CITY OF ALBUQUERQUE

RE: HERITAGE AT THE TRAILS, UNITS 1 & 2 (C-9/D2)
Engineers Certification for Release of Financial Guaranty
Engineers Stamp dated 03/25/2004 (Unit 1)
Engineers Stamp dated 07/26/2004 (Unit 2)
Engineers Certification dated 01/31/2006

**HERITAGE AT
THE TRAILS UNIT 2
GRADING & DRAINAGE PLAN**

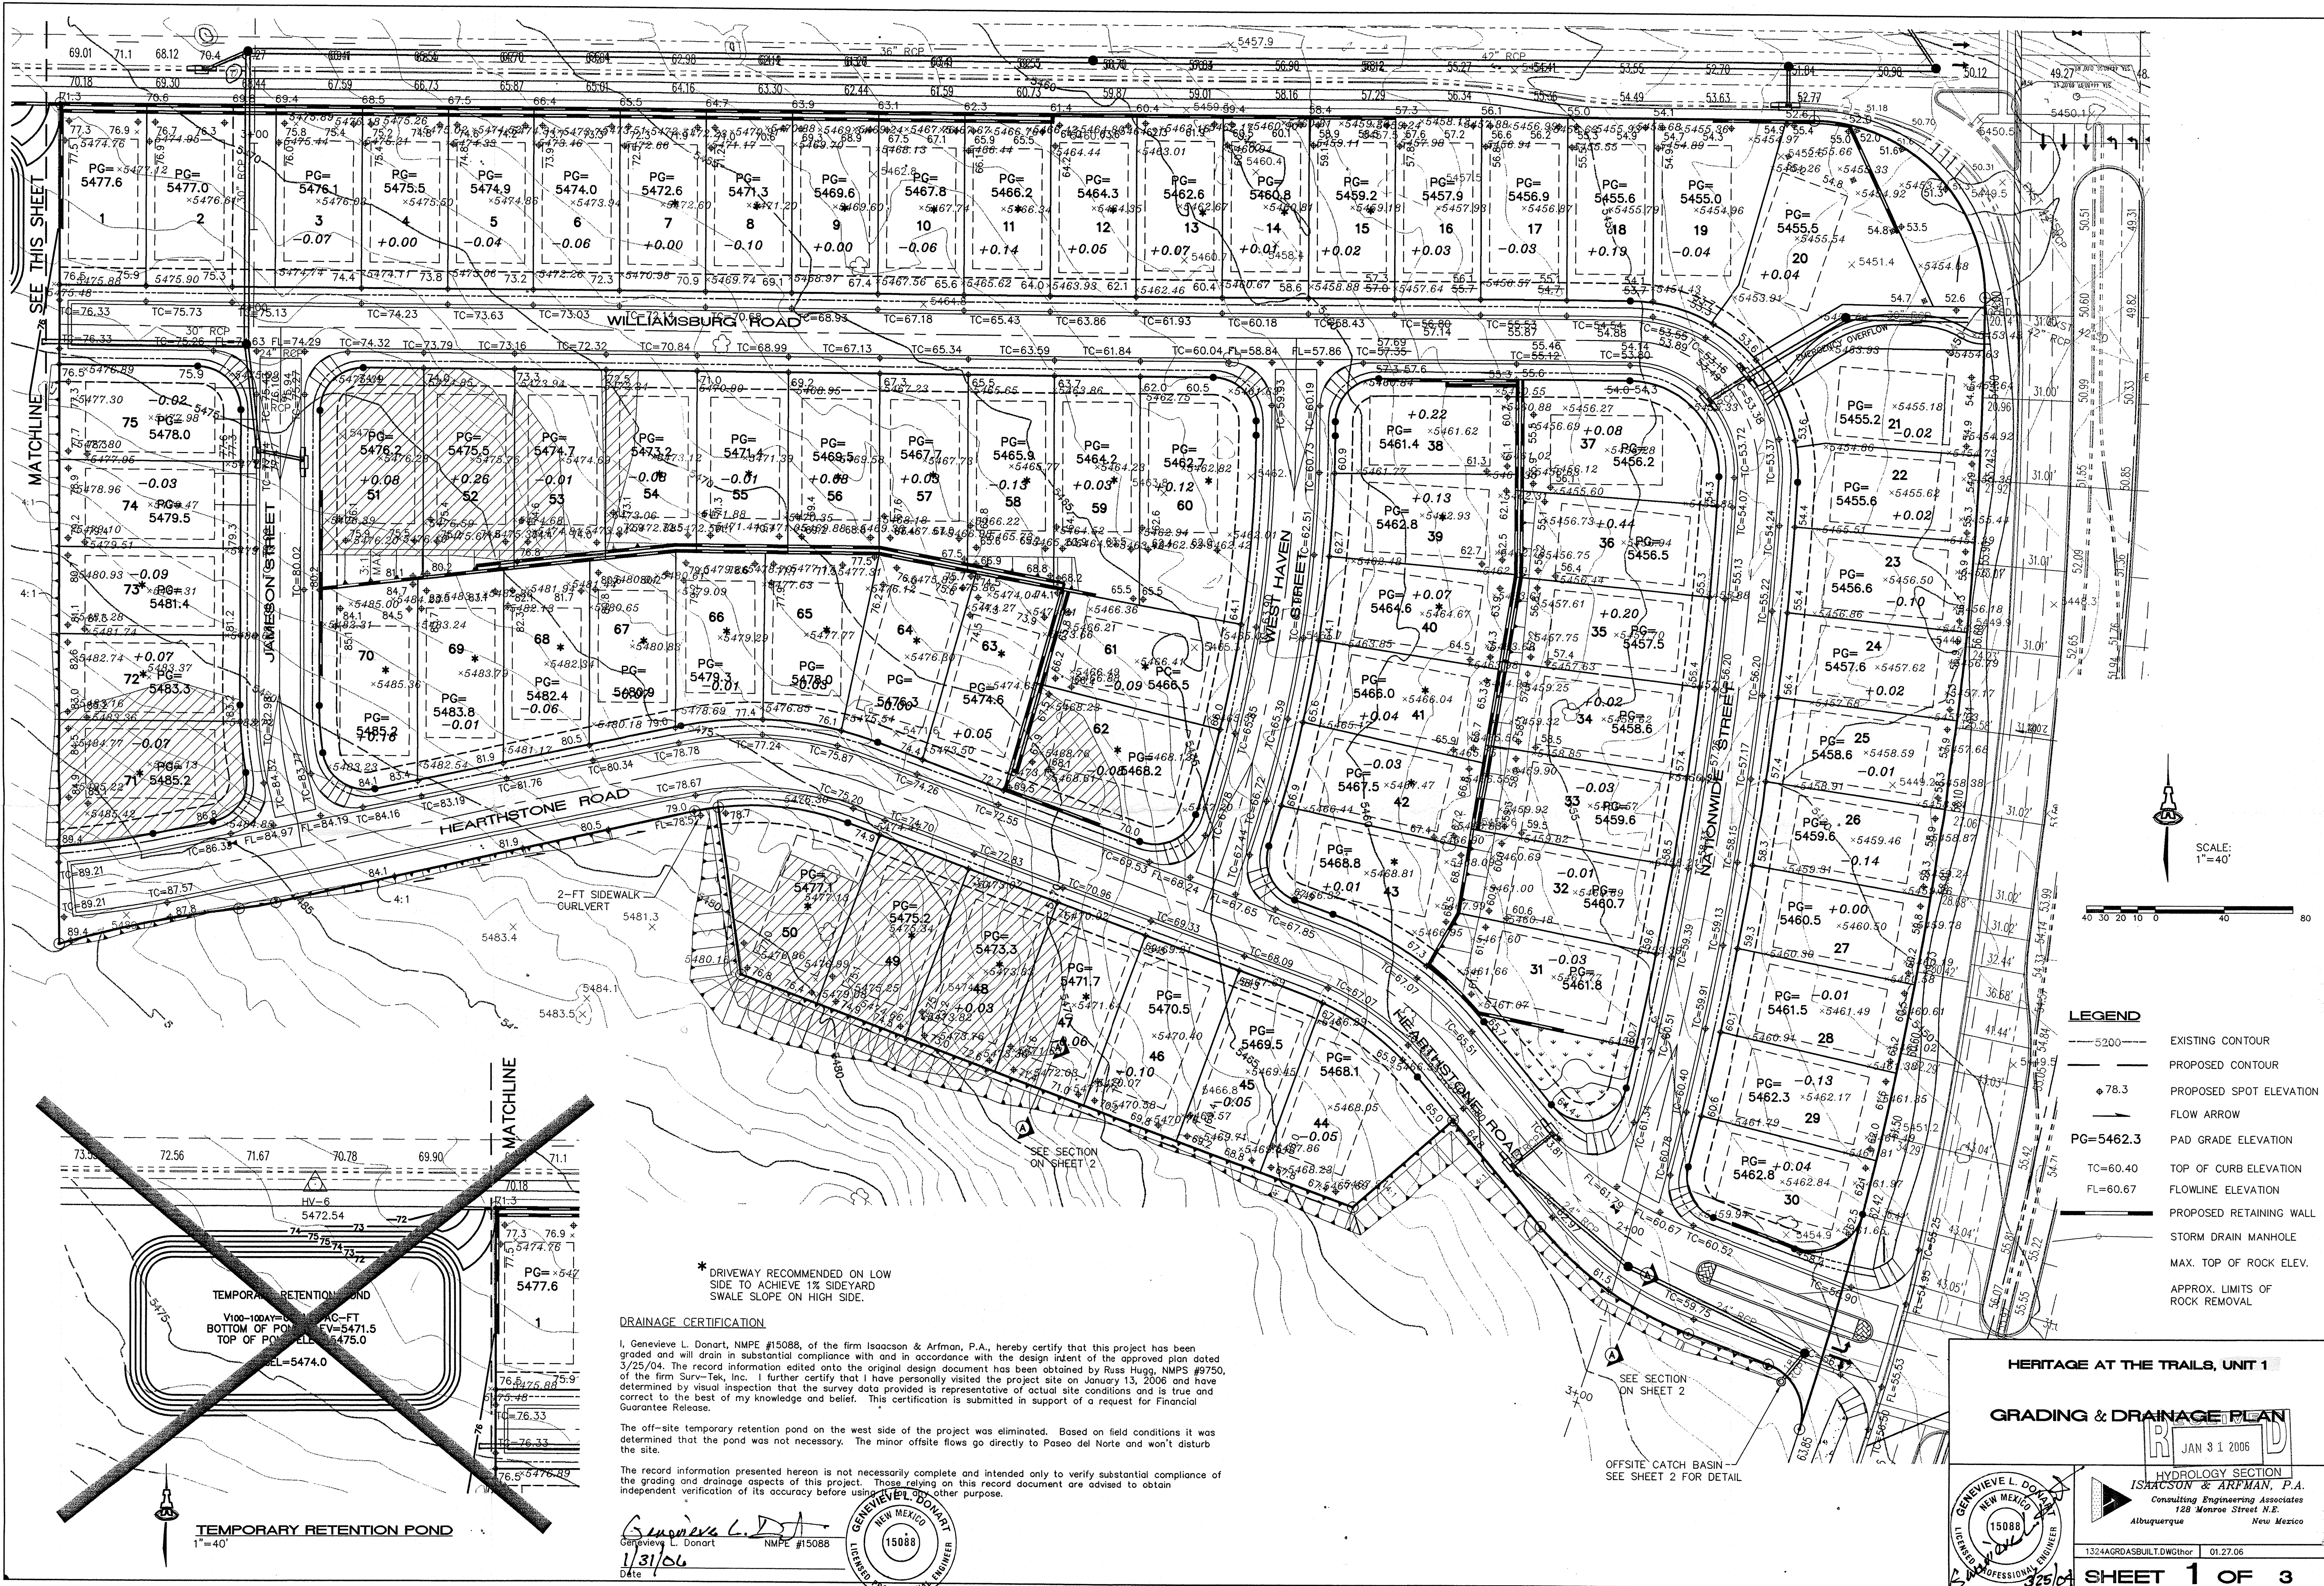
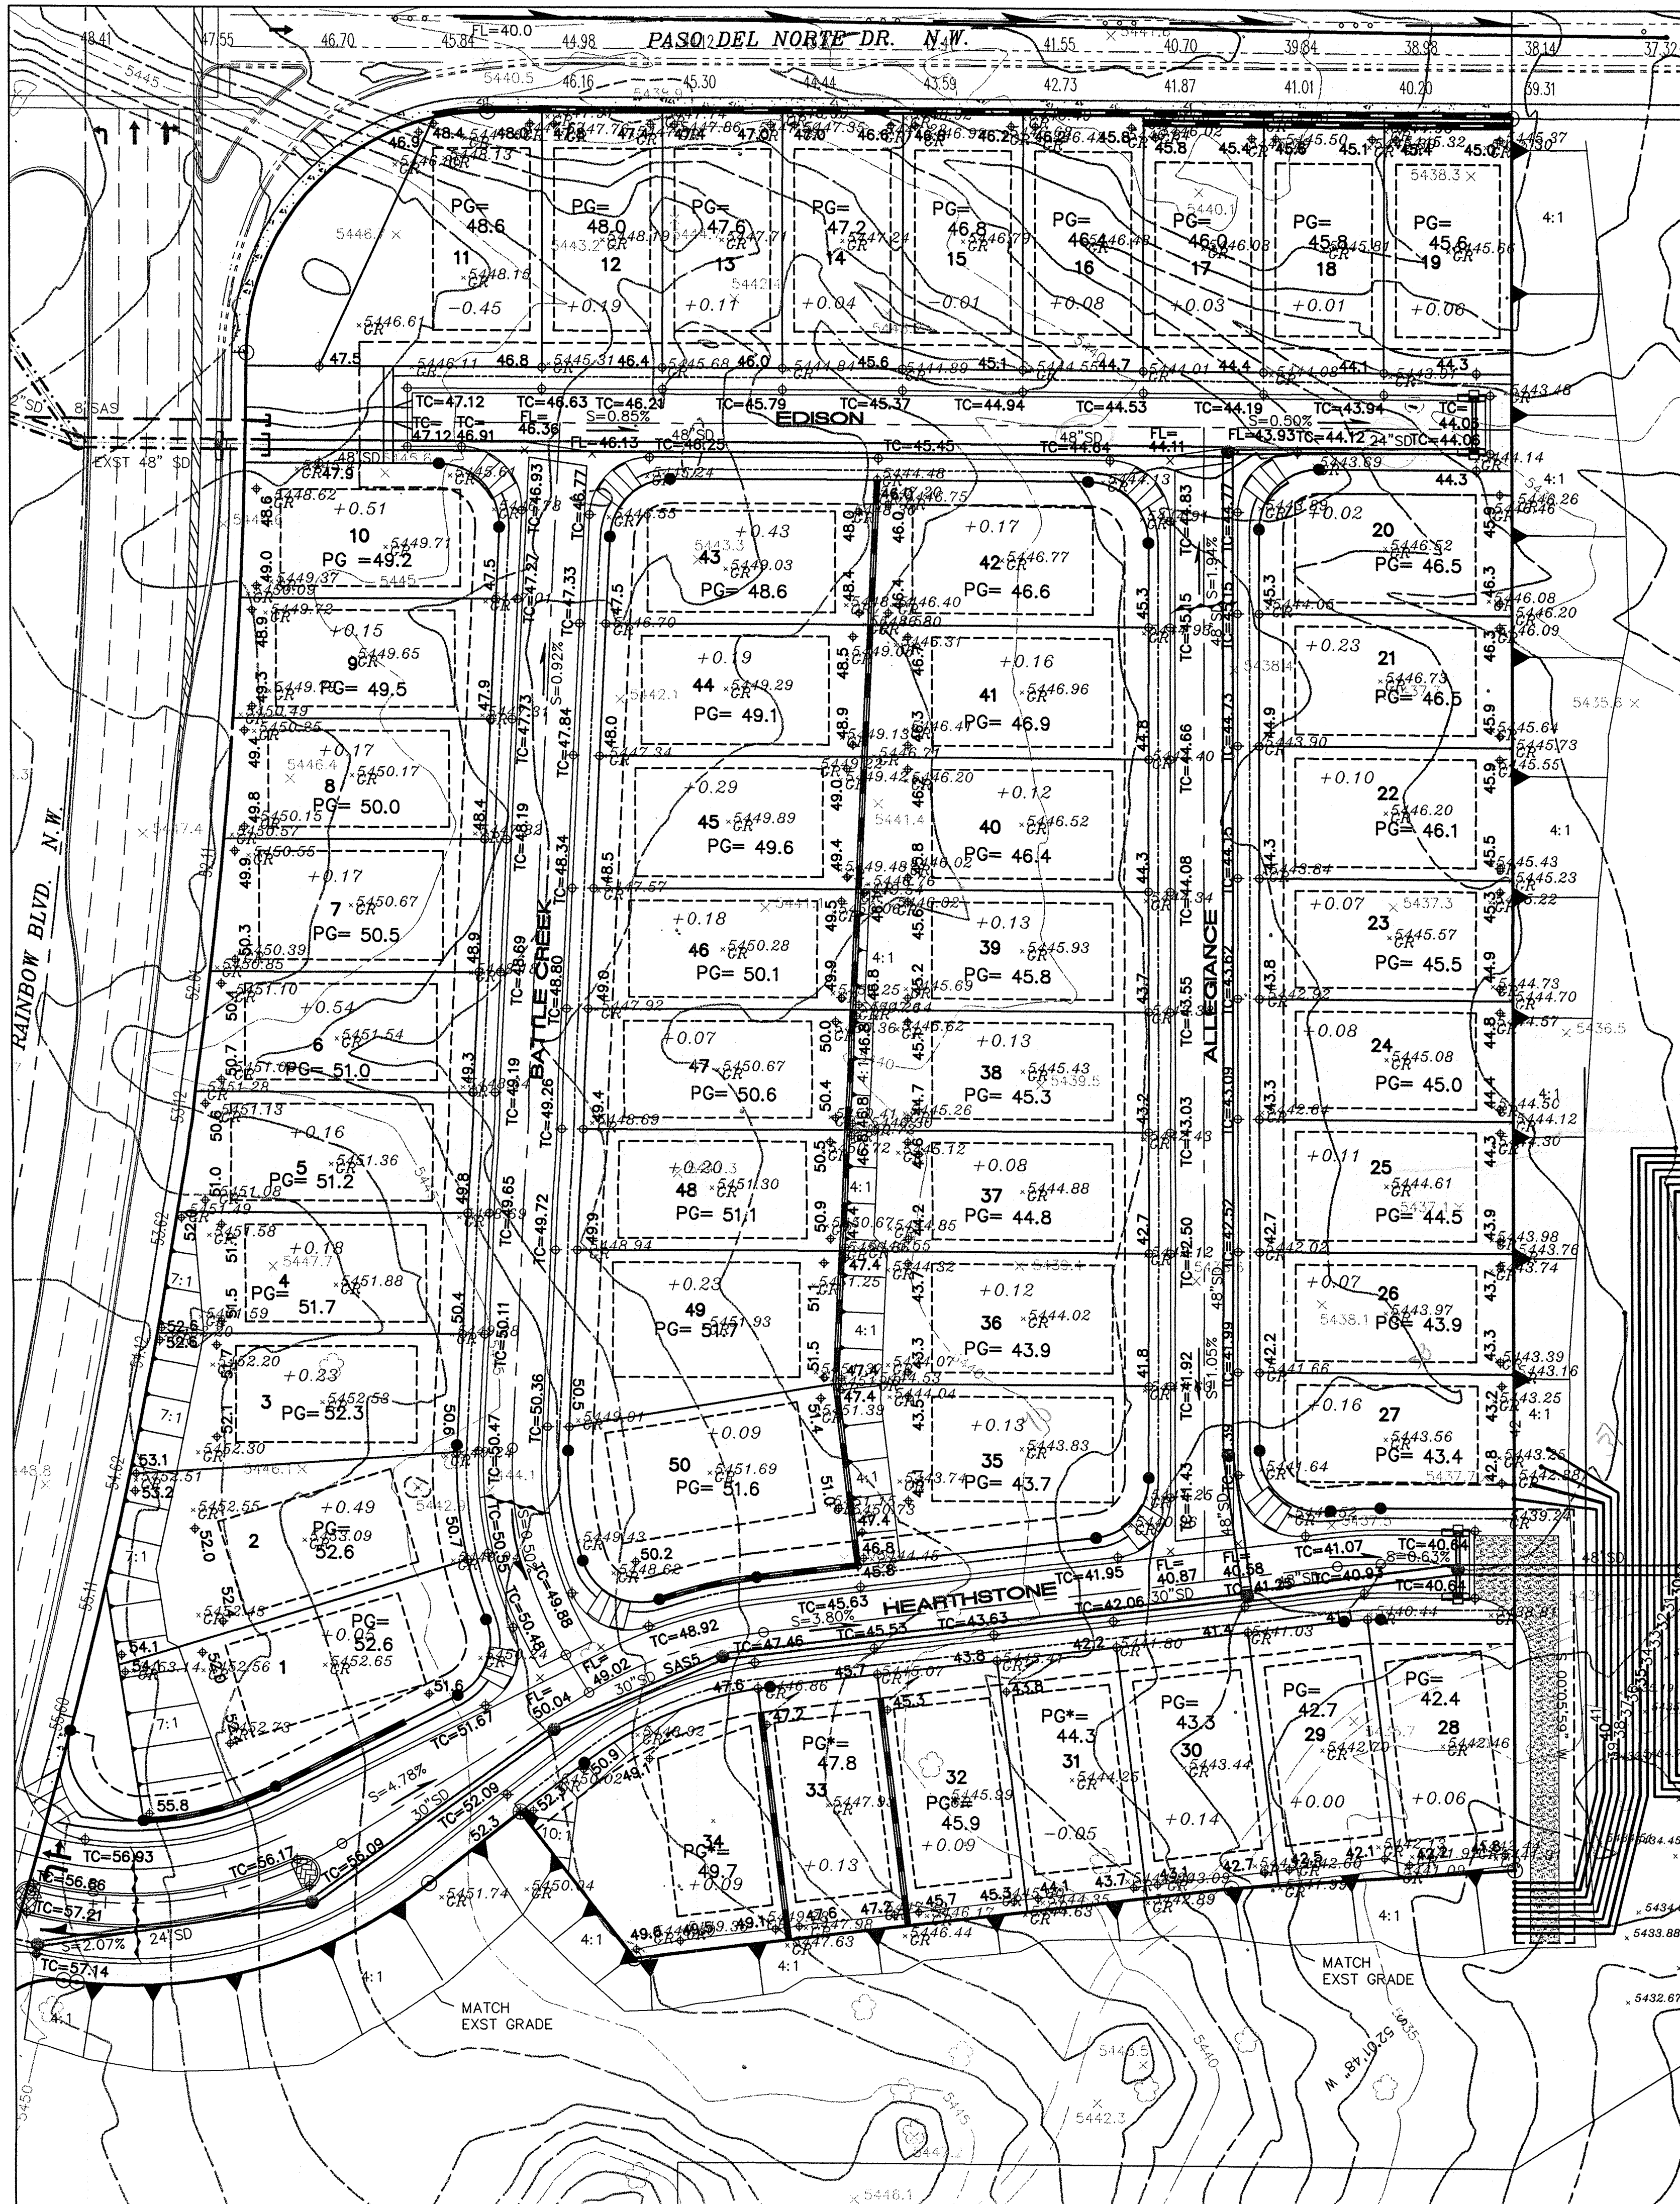
Based upon the information provided in your Engineer's Certification Submittal dated 01/31/2006, the above referenced plan is adequate to satisfy the Grading and Drainage Certification for Release of Financial Guaranty.
